Active Composite Mills Ltd.

21st June 2014

Observations

Tested ground floor column –
Brick aggregate confirmed

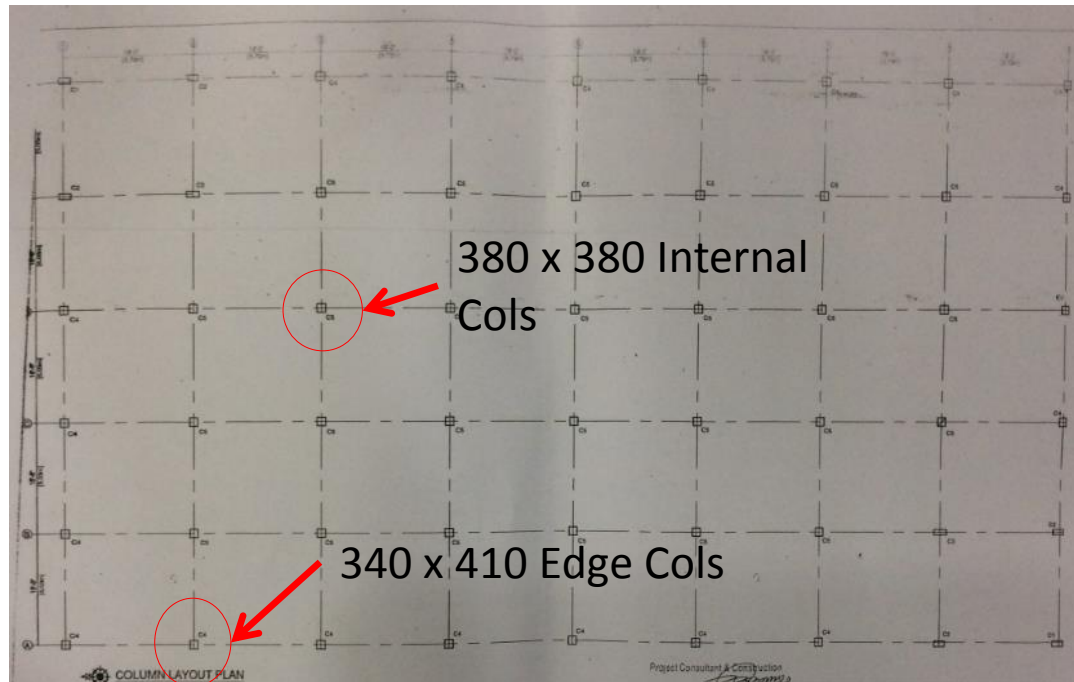
Columns in factory building appear to be stressed in excess of normal design limits

Cursory calculations indicate that columns are highly stressed

Building Engineer is to perform detailed calculations (including preparation of a Detail Engineering Assessment) and concrete tests to prove column size and if required:

- Reduce loads by vacating floors
- Reinforce columns

Typical column layout

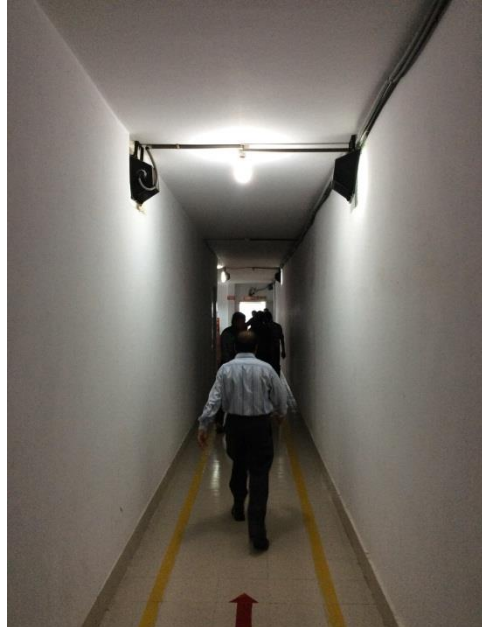
High punching shear stresses in suspended slabs in factory building

Cursory calculations indicate high punching shear stresses in the suspended slabs

Building Engineer to perform detailed calculations and concrete tests to prove punching capacity of floor slabs and, if required:

- Reduce load on slabs
- Reinforce shear capacity of slabs

Cantilever on 1st floor not shown on drawing

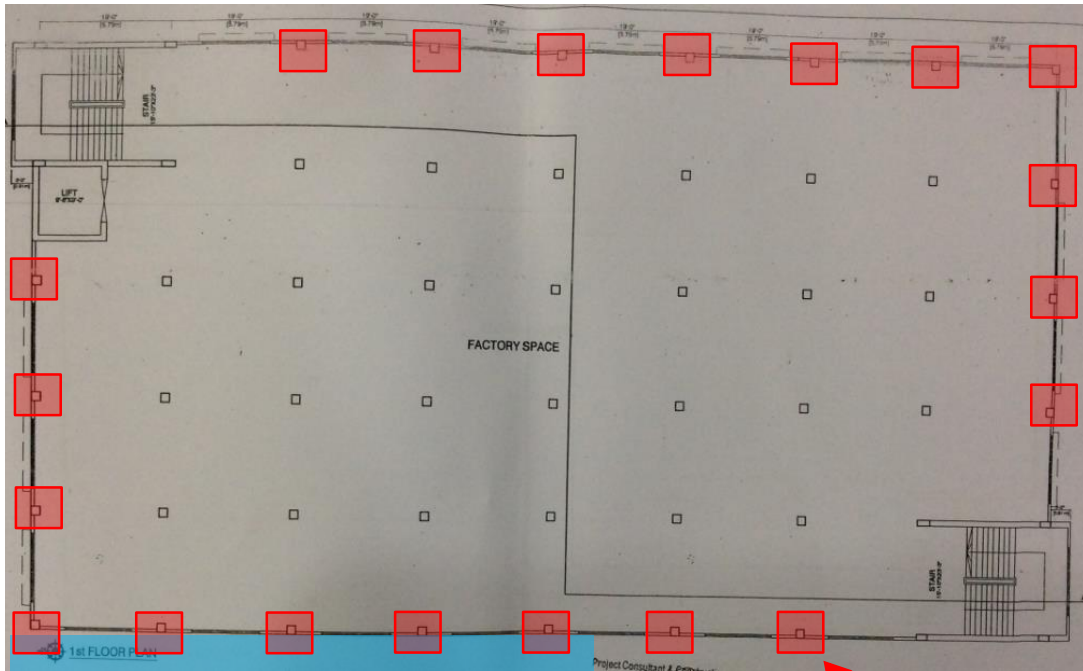
Structural drawings not consistent with the as-constructed arrangement of the factory

Constructed perimeter columns smaller than indicated on the structural drawings. Building engineer to survey and update drawings as required.
